Project	IEEE 802.16 Broadband Wireless Access Working Group < http://ieee802.org/16 >	
Title	Hierarchical MAP Structure	
Date Submitted	2004-11-04	
Source(s)	Hang Zhang, Mo-Han Fong, Peiyong Zhu, Wen Tong Nortel Networks	mhfong@nortelnetworks.com Voice: +1-613-765-8983 Fax: +1-613-765-6717
Re:	IEEE P802.16e/D5-2004	
Abstract	This contribution proposes to enhance the DL/UL MAPs to improve power efficiency for MSS in Sleep mode and Idle mode, and also to reduce overhead.	
Purpose	Review and Adopt the suggested changes into P802.16e/D5	
Notice	This document has been prepared to assist IEEE 802.16. It is offered as a basis for discussion and is not binding on the contributing individual(s) or organization(s). The material in this document is subject to change in form and content after further study. The contributor(s) reserve(s) the right to add, amend or withdraw material contained herein.	
Release	The contributor grants a free, irrevocable license to the IEEE to incorporate material contained in this contribution, and any modifications thereof, in the creation of an IEEE Standards publication; to copyright in the IEEE's name any IEEE Standards publication even though it may include p

Figure 1. Hierarchical MAP structure

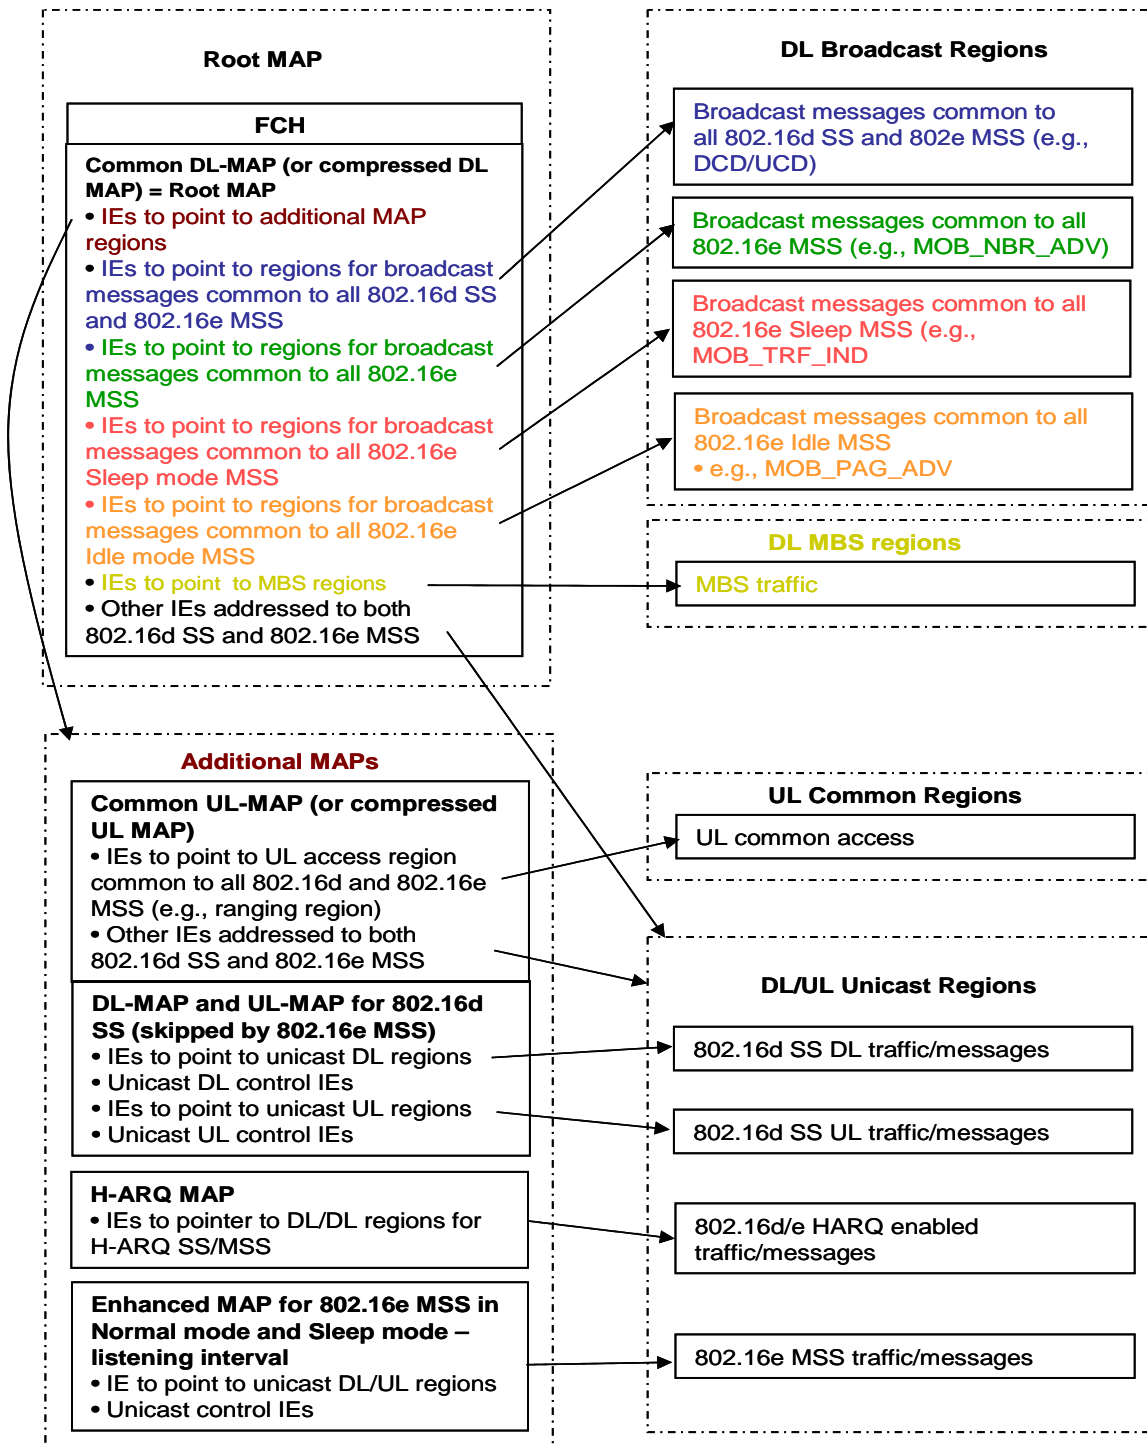
We propose a hierarchical MAP structure as shown in Figure 1. We use the first DL-MAP following the FCH as the Root MAP. Since this Root MAP is processed by all MSSs who intend to listen to DL traffic or messages including SS, MSS in Normal mode, MSS in Sleep mode – listening window, and MSS in Idle mode – Paging interval, this Root MAP contains IEs that points to additional DL and UL MAPs, where each of these additional MAPs only needs to be processed by a specific group of MSS, e.g. 802.16d SS, or 802.16e MSS in Normal mode, or 802.16e MSS in Sleep mode – listening window, or 802.16e in Idle mode – paging interval.

One example of how the MAPs can be partitioned is illustrated below and in Figure 1 (note that the regions shown in the figure are logical region rather than actual physical subchannel and OFDMA symbol space). In this example, the Root MAP includes the following:

- IEs to point to additional DL/UL-MAPs which only need to be processed by specific groups of MSSs. The additional MAPs include:
 1. MAP for UL common access (i.e. ranging) for all 802.16d SS and 802.16e MSS. This MAP is processed by all 802.16d SS and 802.16e MSS that intends to perform UL access;
 2. Unicast DL/UL MAP for all 802.16d SS. This MAP is processed by all power-on and registered 802.16d SS. This MAP is skipped by all 802.16e MSS (using the new Skip_IE).
 3. Unicast DL/UL MAP for all 802.16e MSS in Normal mode and Sleep mode – listening interval. This MAP is processed by all 802.16e MSS in Normal mode or Sleep mode – listening interval.

- IEs to point to OFDMA regions for DL broadcast messages. The broadcast regions can be divided into four types:
 1. region containing common broadcast messages for all 802.16d SS and 802.16e MSS, e.g. system parameter broadcast (UCD, DCD) messages;

2. region containing broadcast messages for all 802.16e MSS, e.g. neighbor BS information advertisement (MOB-NBR-ADV) message;
 3. region containing broadcast messages for all Sleep mode MSS, e.g. traffic indication (MOB-TRF-IND) message;

4. region containing broadcast messages for all Idle mode MSS, e.g. paging advertisement (MOB-PAG-ADV) message.
 In this way, an MSS operating in certain mode only needs to process the corresponding region and messages instead of having to process all broadcast regions and messages.

- IEs to point to regions for multicast-broadcast service (MBS) traffic. A particular MBS region is demodulated and decoded by MSS that are subscribed to the associated MBS.

- IEs that are addressed to both 802.16d SS and 802.16e MSS, e.g. MIMO_DL_Basic_IE etc.
